Re: Application Z23-008
Klein Outdoor Advertising, Inc.
9 Route 440

Please accept this letter as response/supplement to your 2/27/23 incompleteness report. We offer the following responses, referencing your incompleteness report:

Jersey City Circulation Element 2050 Figure 4.4-1: Right of Way Needs City of Jersey City Hudson County, New Jersey

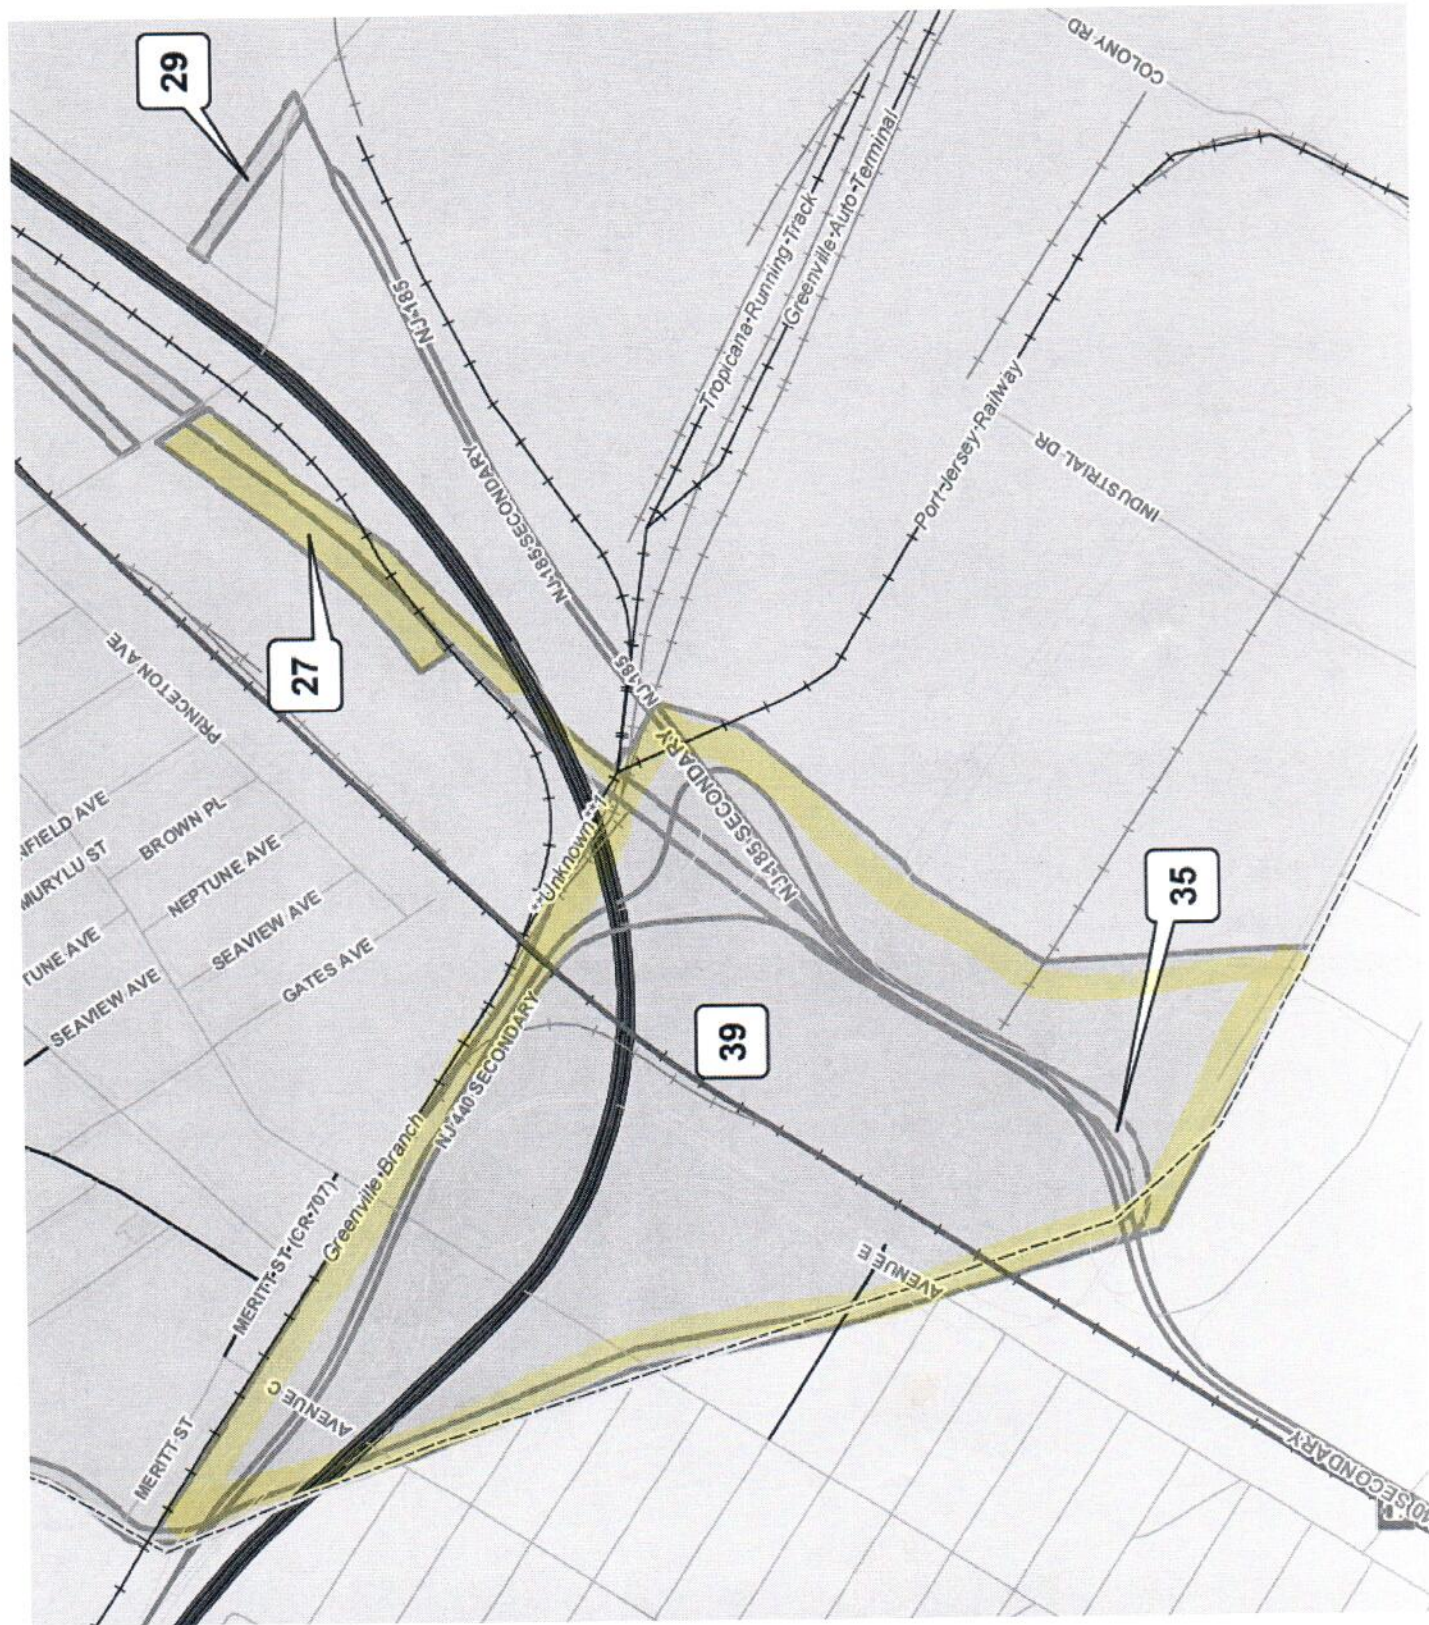
1. *Review Agents Sets (Upon staff request).*
Pending upon staff request.
3. *Indication of review/approval by NJDEP, ACOE, and JC Environmental Commission.*
NJDOT Permit enclosed. NJDEP, ACOE – not applicable; JC Environmental – pending.
4. *Indication of property contains a Right-Of-Way Preservation area per Map 4.4-1 of JC Master Plan Circulation Element.*
Copy of map enclosed with subject property identified as Area 39 highlighted, showing no easement.
